Proposal No. 608051-132406

ADDENDUM NO. 5

**Federal Aid Project No. STP/CMQ/HSI-0034(030)X
Reconstruction on Route 38 (Main Street), from Route 62 to the Woburn C.L.**

Questions and Responses

RETAINING WALL
PLAN AND ELEVATION

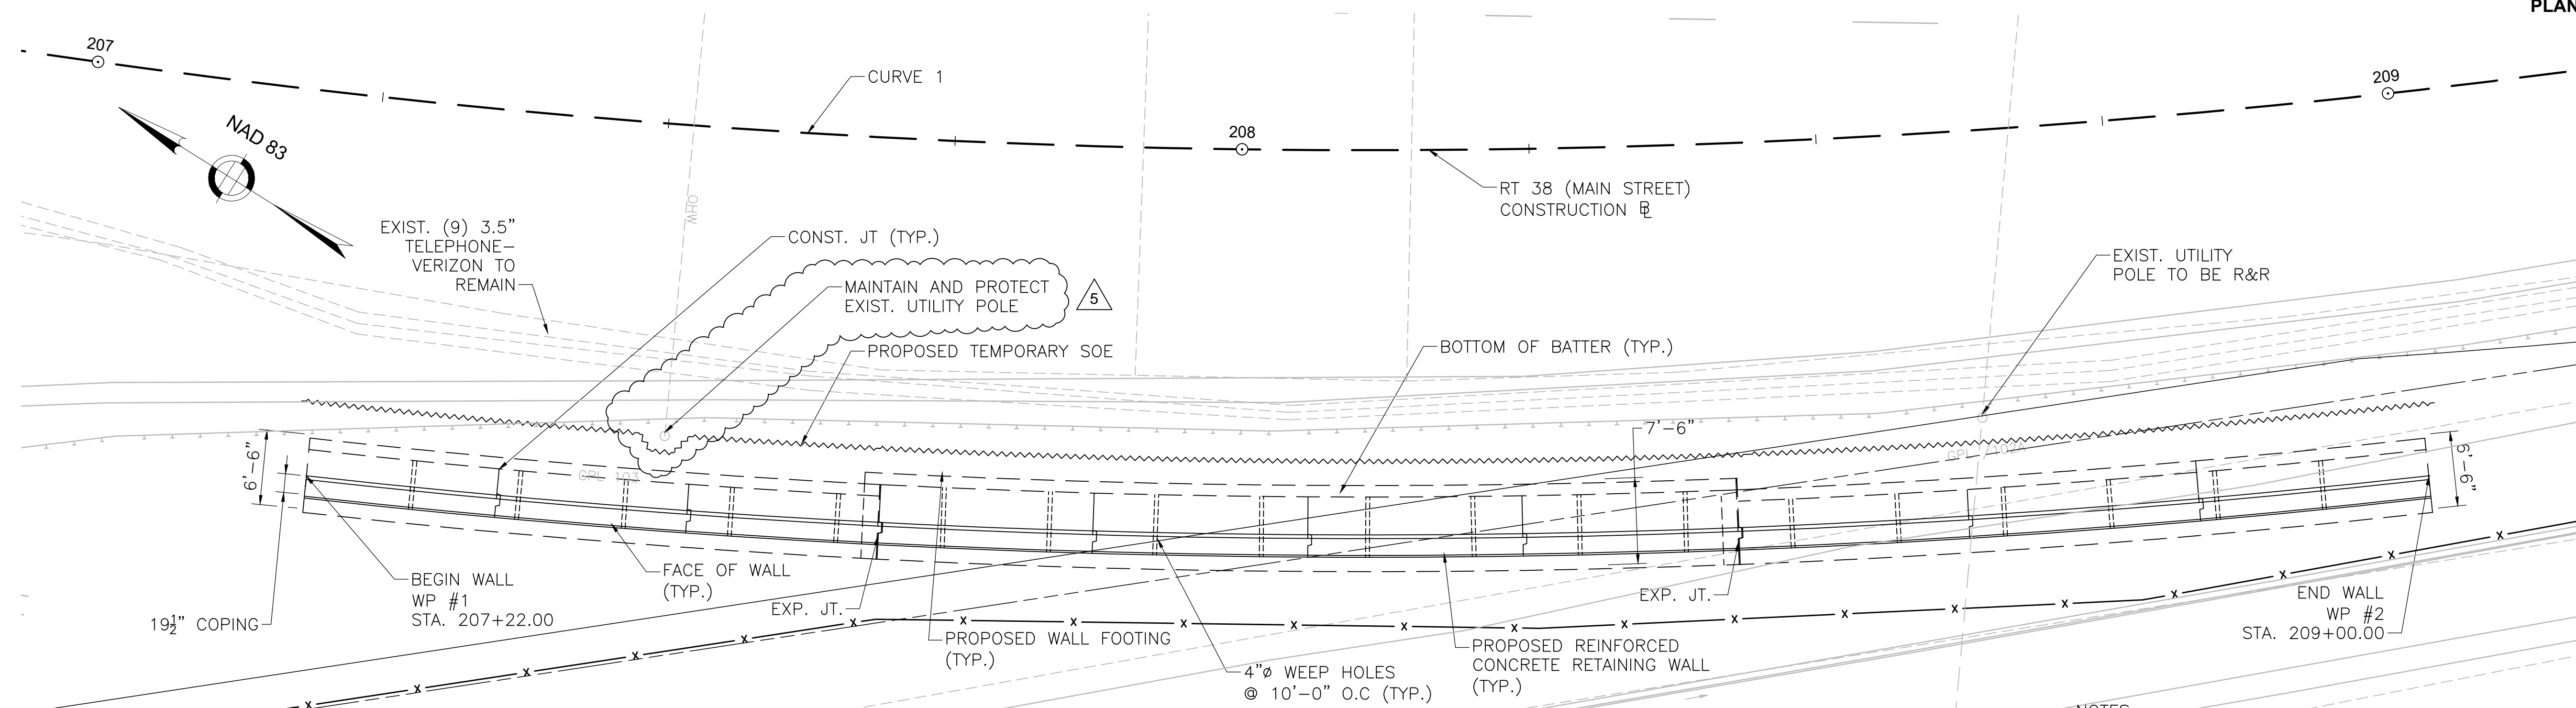
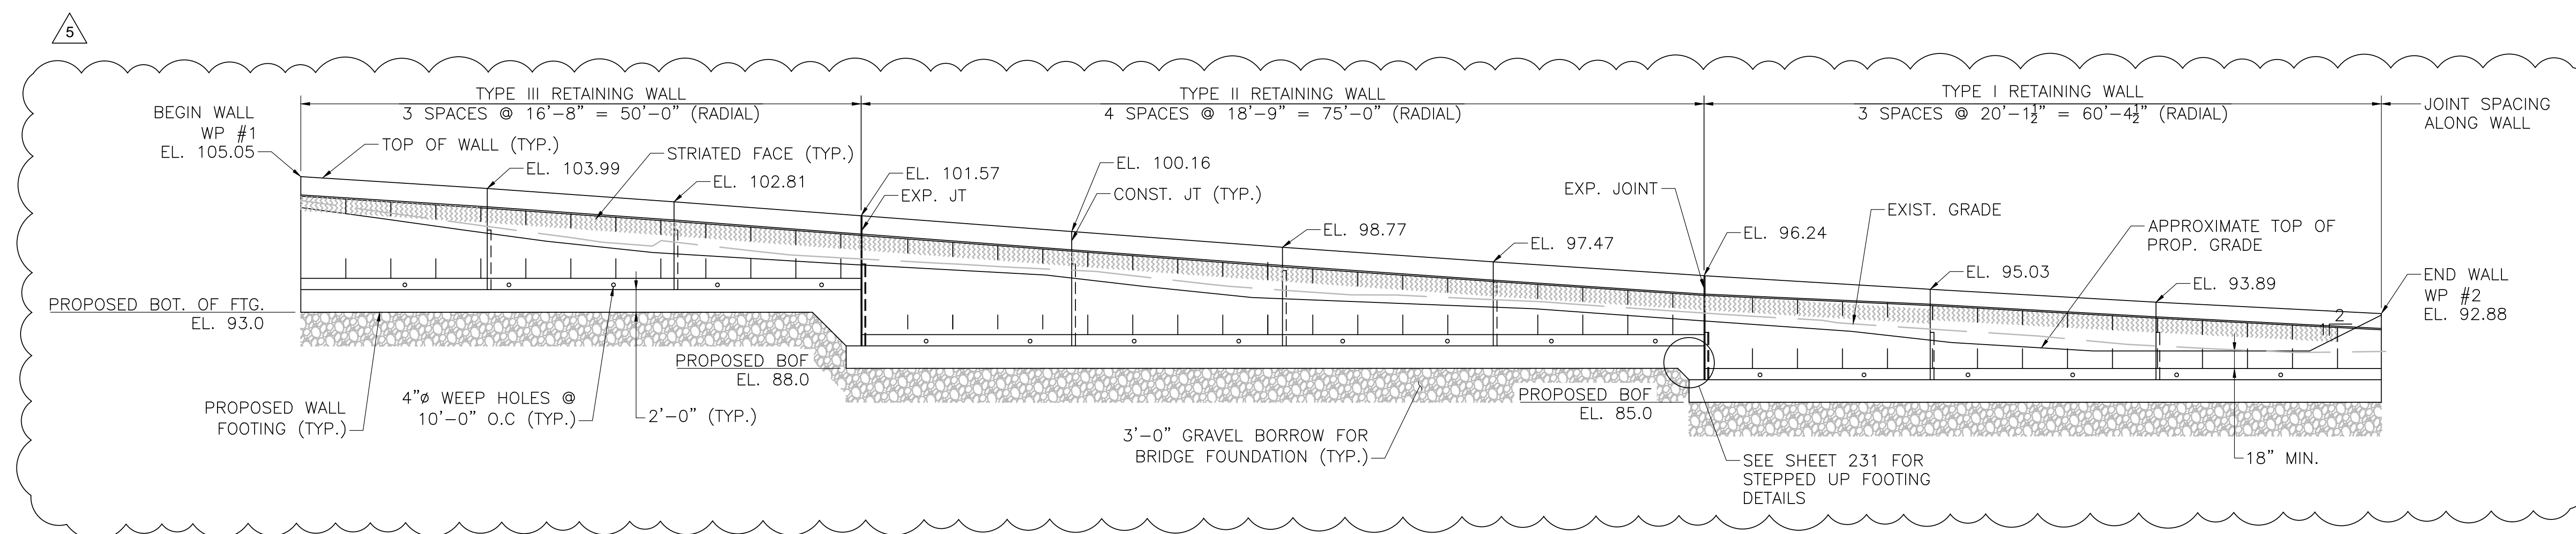
Question 34) Please reference plan sheet 115. Utility pole #103A at approximately station 207+50 RT, is to be removed and reset with a new guy wire. The new location of the pole and guy wire appear to interfere with the construction of Wall #1 footing and the new fence. Please clarify the location of relocated utility pole 103A.

Question 39) Wall No. 1 Elevation shown on plan sheet 229 seems to have some discrepancies in the measured height of the wall vs the elevations given on the detail. The wall portion is measuring about 5” taller than the elevations shown. For example, WP#1 is at El. 105.05, with a top of footing elevation of 95.0, totaling a wall height of 10.05’. However, this height is scaled off the plans at 10’ 5”. Please clarify the actual wall heights and revise the Wall Elevation Plan as necessary.

Response 34) See the revised Plans Sheet 229 for the revised SOE. The permanent relocation of Pole 103A is anticipated to be within the sidewalk in front of the proposed guardrail, provided a minimum 4'-0" clear path (excluding the curb width) is maintained. A caisson may be required based on sequencing and means and methods. Final pole relocation and guy anchor locations shall be coordinated with Verizon during construction. The fence between Station 207+00 RT and Station 210+60 RT is temporary and may be adjusted within the easement as needed.

Response 39) See the revised Plans Sheet 229. The elevations provided on the Plans should be used and not the scaled dimensions.

EAST HEADWALL DETAILS

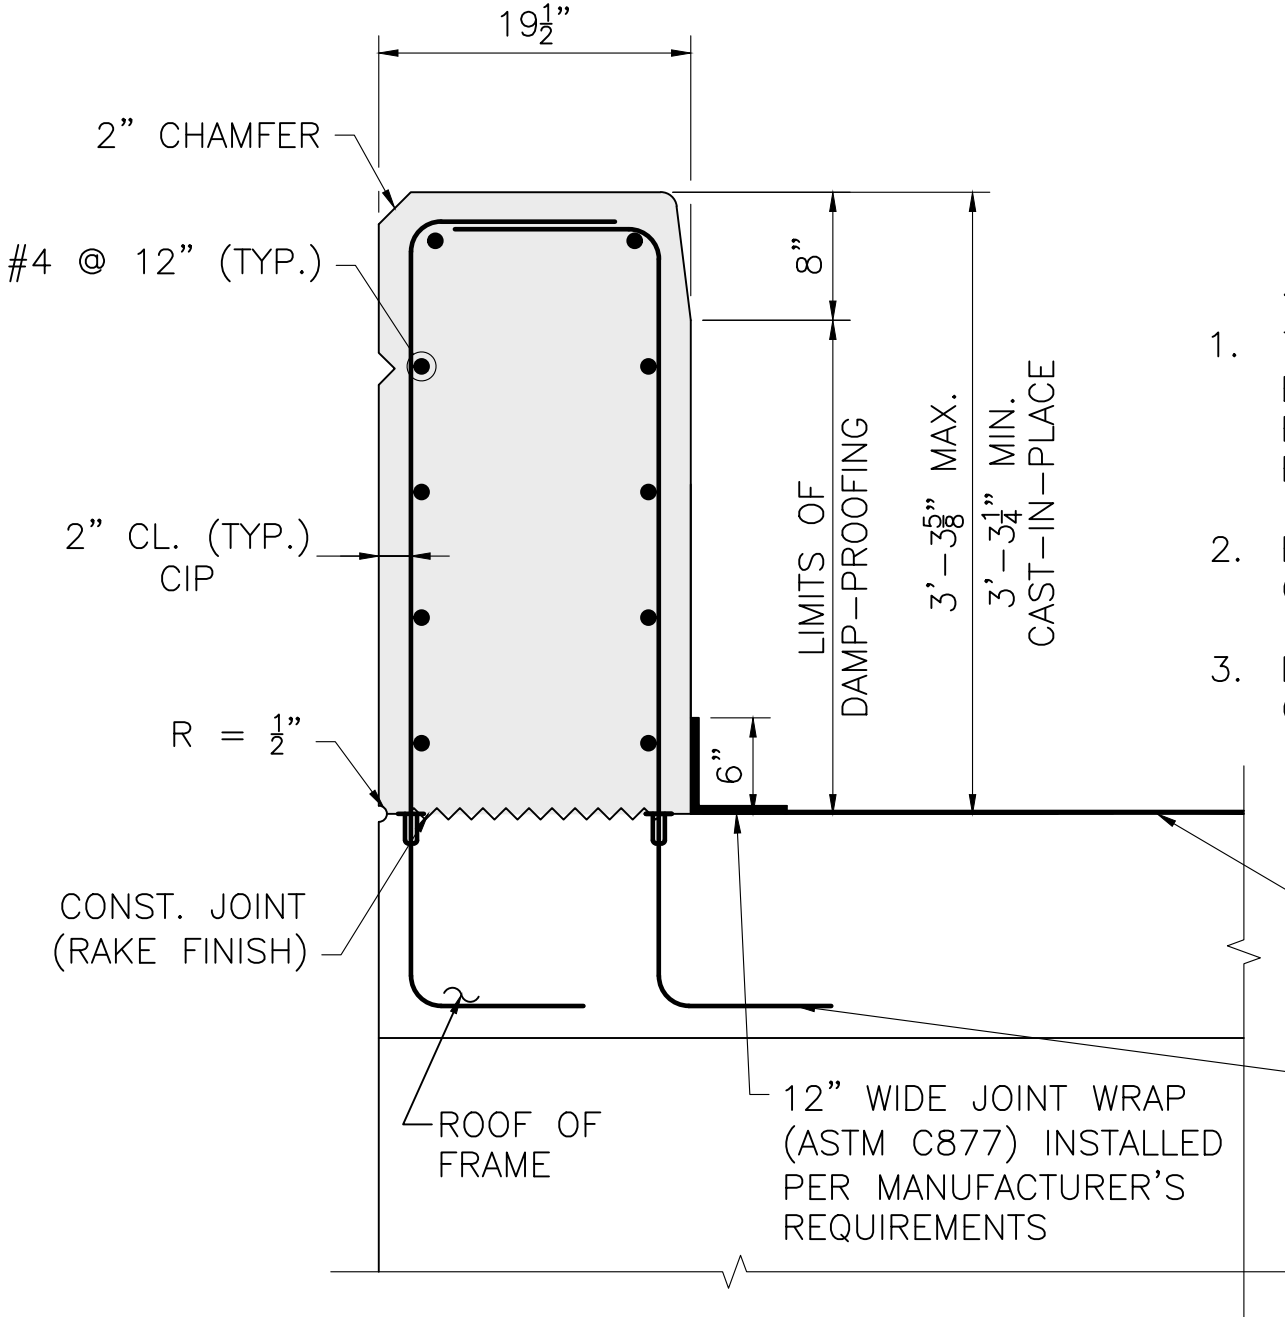
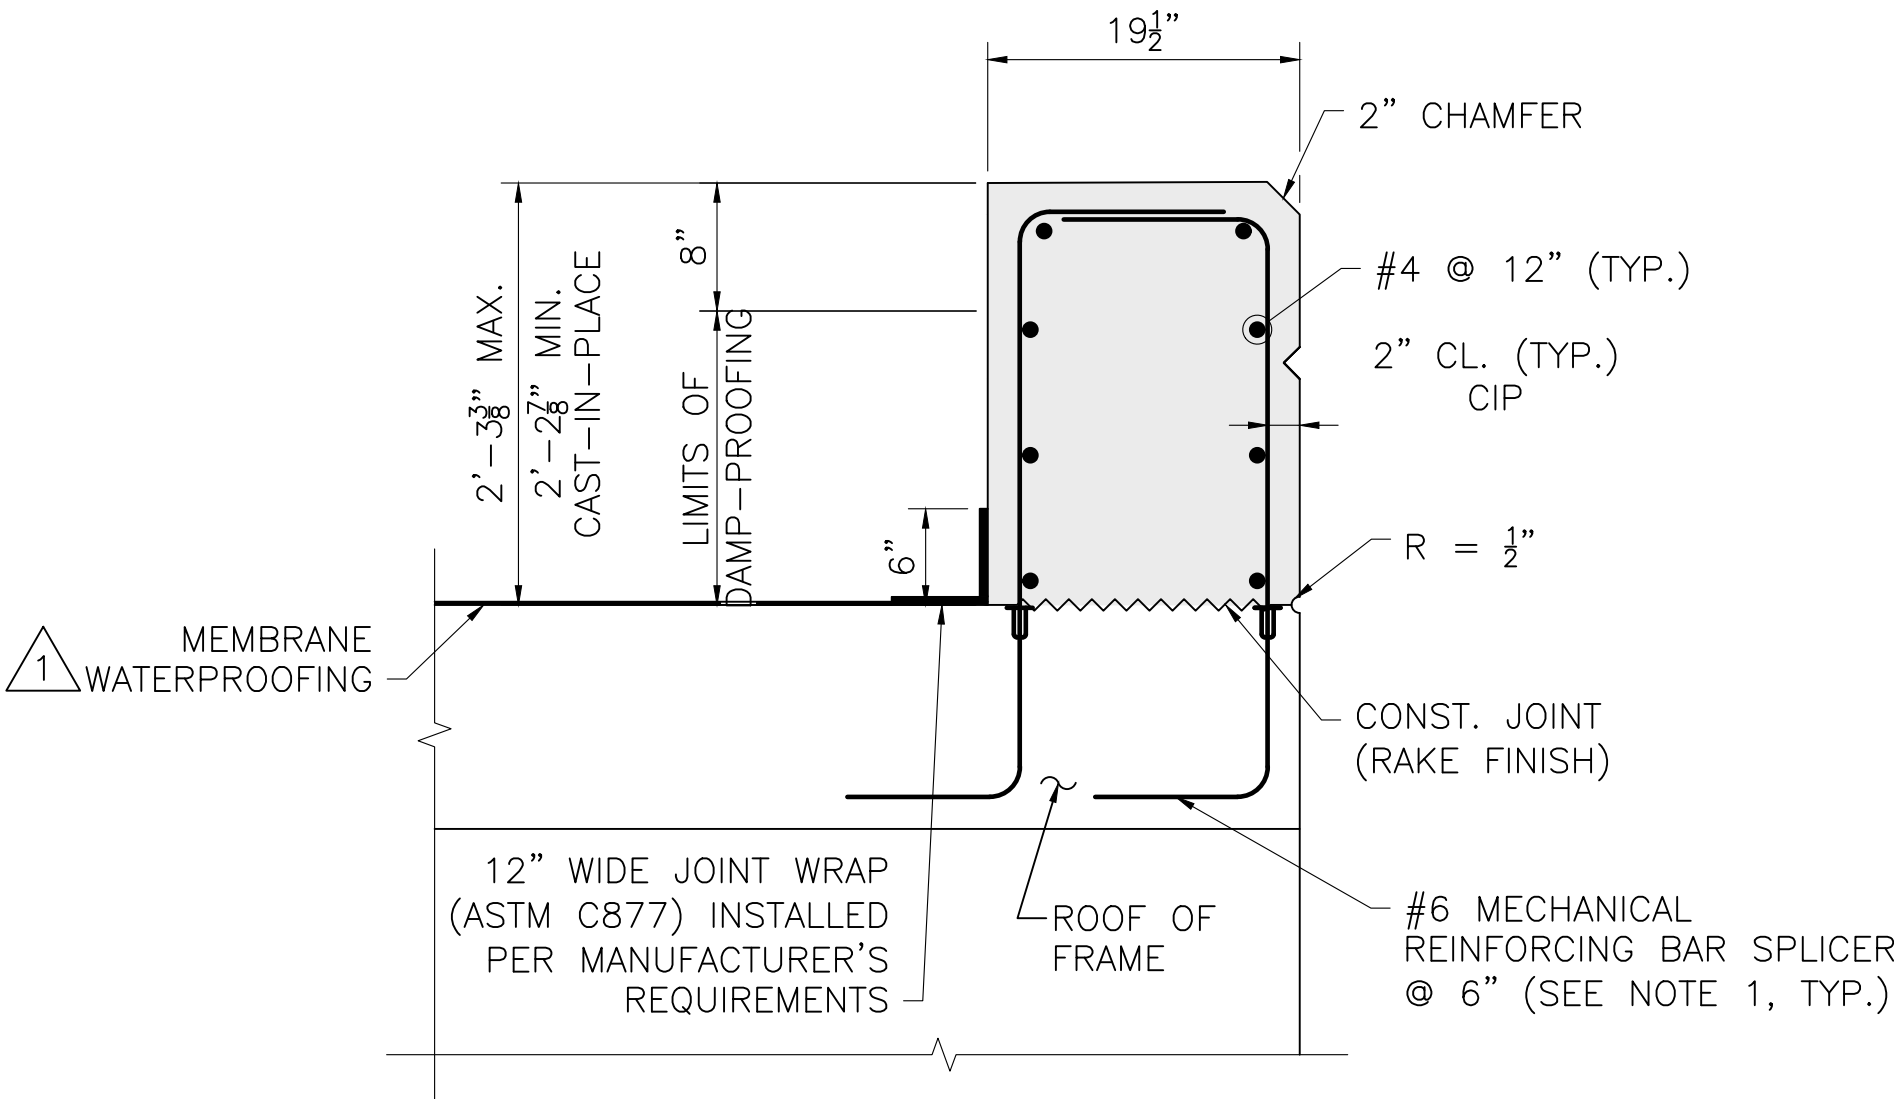
Question 33) Please reference plan sheet 255 (Bridge Sheet 20/26). Can you please add the limits of Membrane Waterproofing to the “East Headwall Details” and the “West Headwall details.

Response 33) See the revised Plans Sheet 255.

TYPICAL BRIDGE SECTION

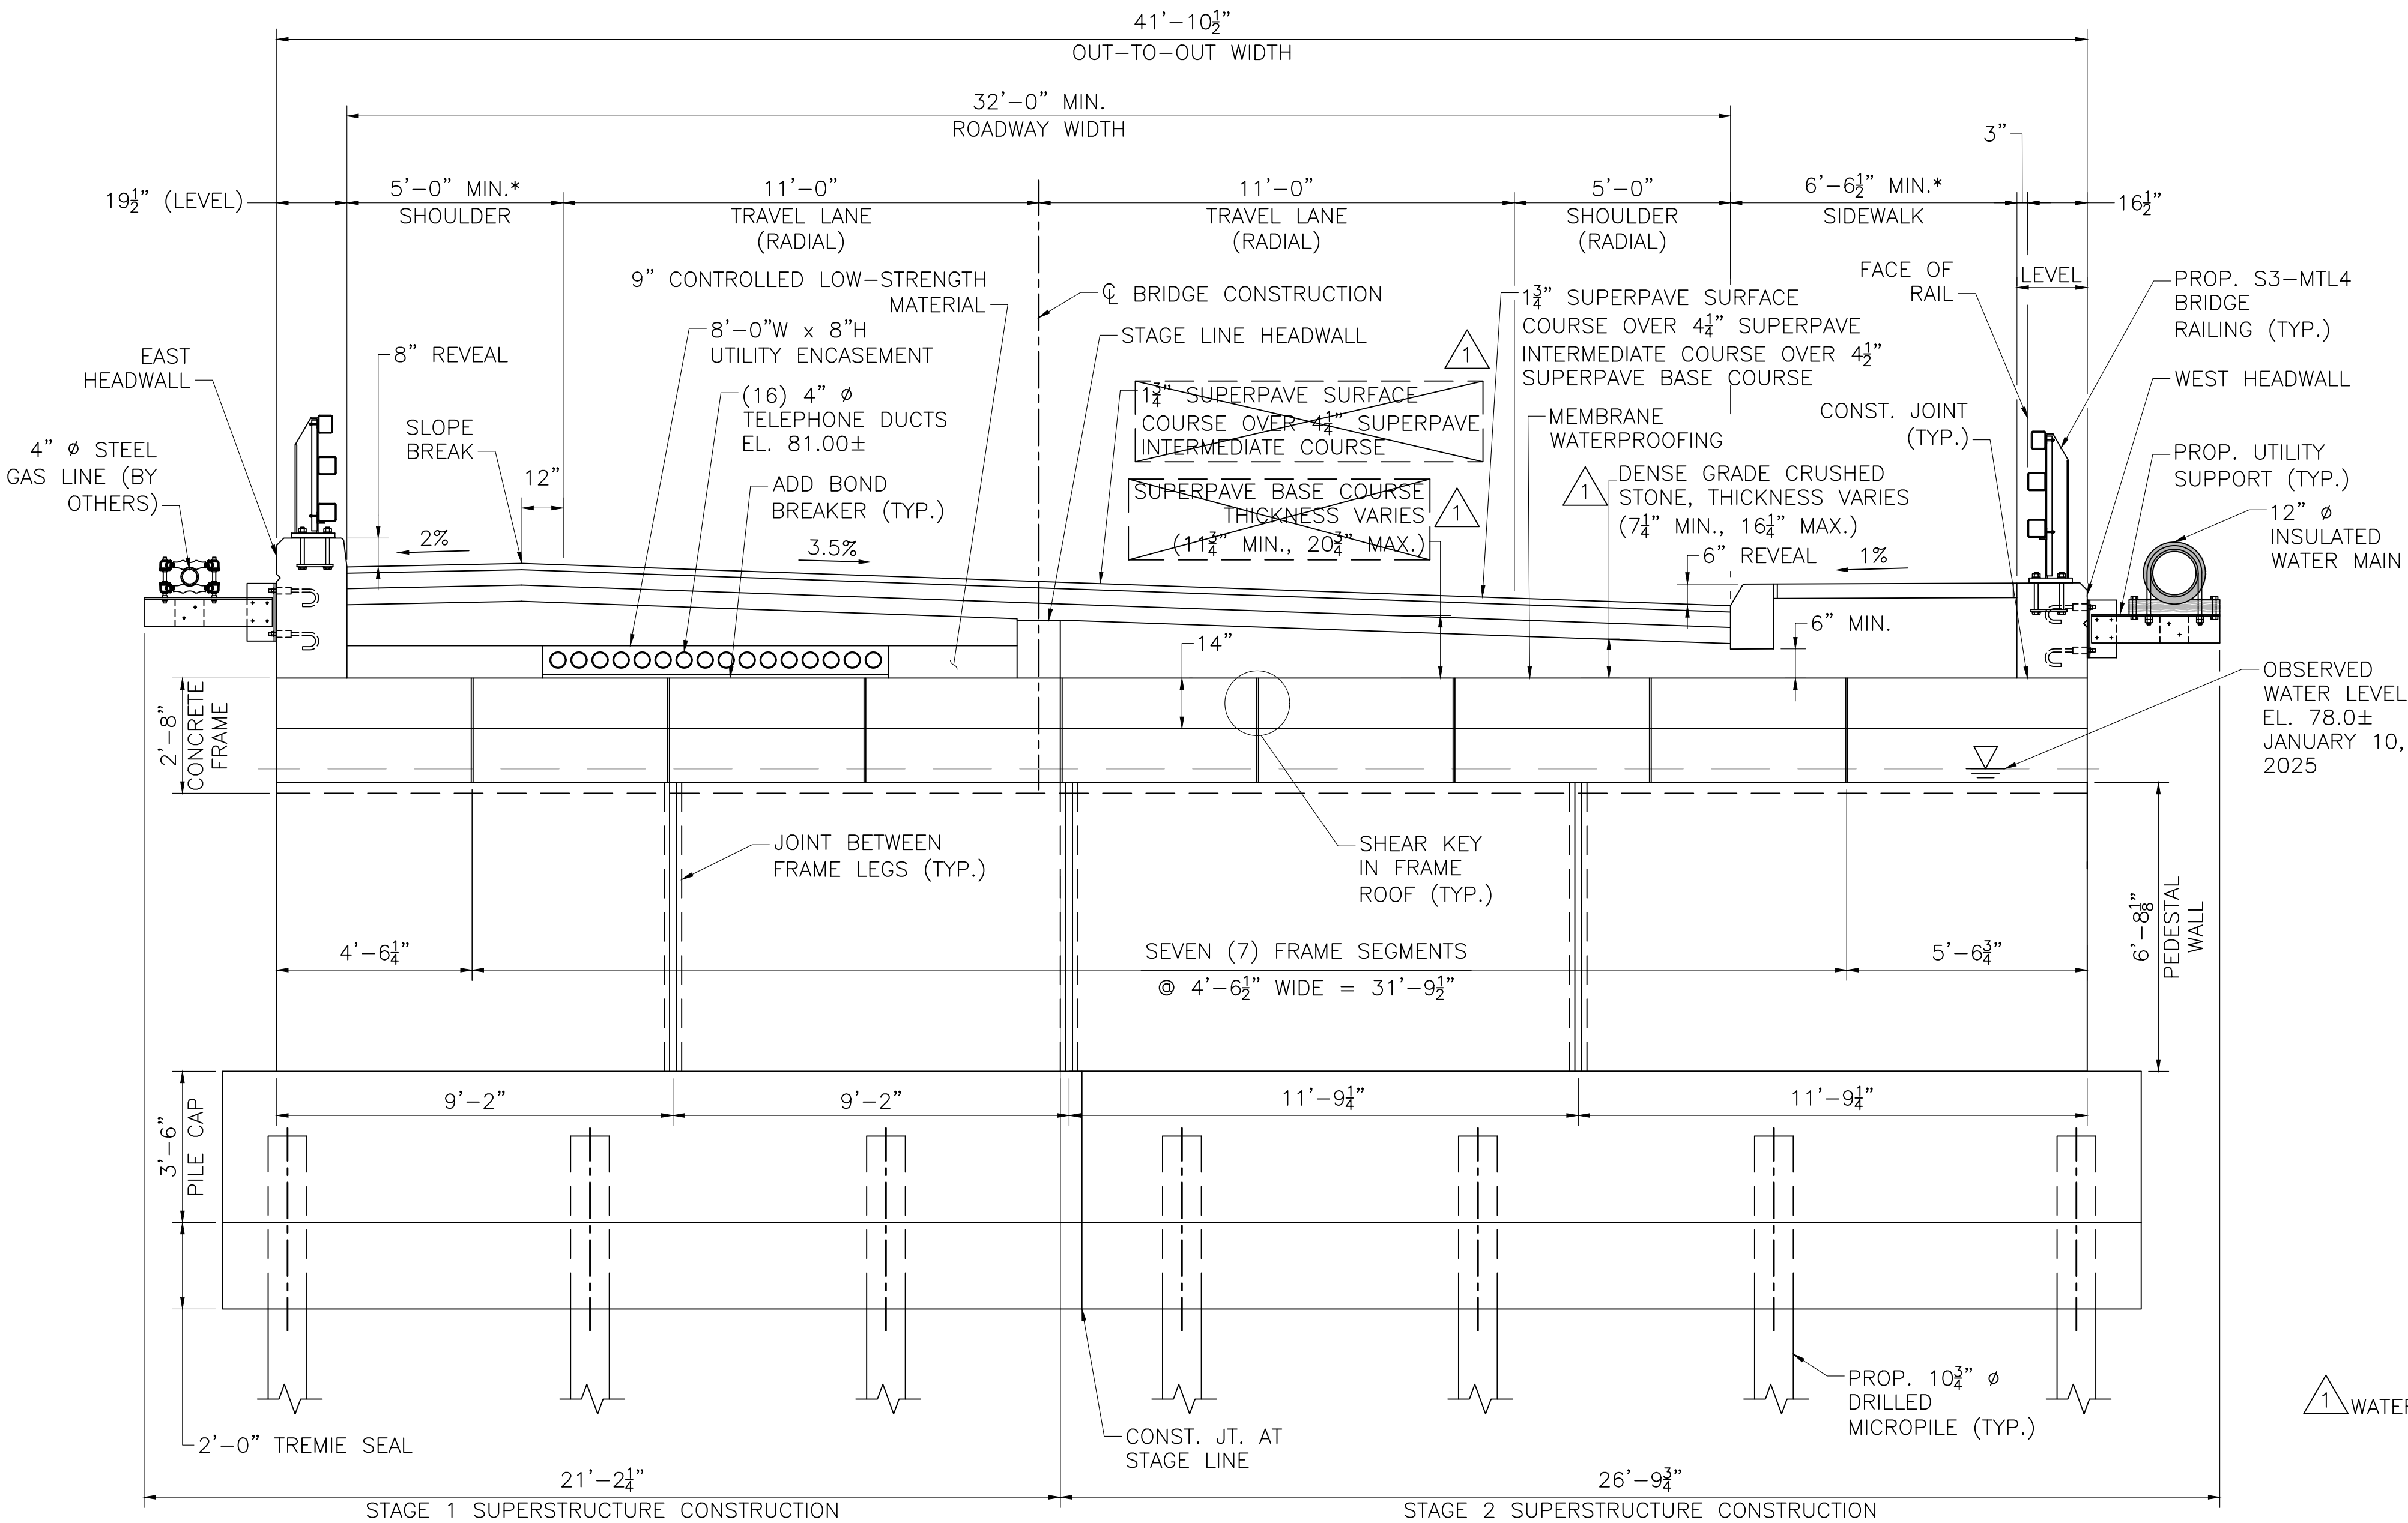
- Question 16) On sheet 14 of 420 under the section "Proposed Bridge Pavement", it calls for Superpave Base Course 37.5 "variable thickness". Please provide a range of depth the contractor may expect here.

Question 32) Please reference Plans Sheets 255 (Bridge Sheet 20/26). The "Typical Bridge Section" appears to indicate that there will be Superpave Base Course below the cast-in-place sidewalk curb and the cast-in-place sidewalk. Can you please provide a detail clarifying the limits of Superpave Base Course in this area, and provide a detail if gravel is required below the cast-in-place curb and sidewalk.

- Response 16) See the revised Sheet 255. The depth of the Superpave Base Course 37.5 at the bridge has been revised to 4.5" over variable depth dense graded crushed stone.

Response 32) See the revised Plans Sheet 255. Between the curb lines, there will be a Superpave Base Course 4.5" thick with a varying depth Dense Grade Crushed Stone for the remaining fill material. That same material should be used below the sidewalk.
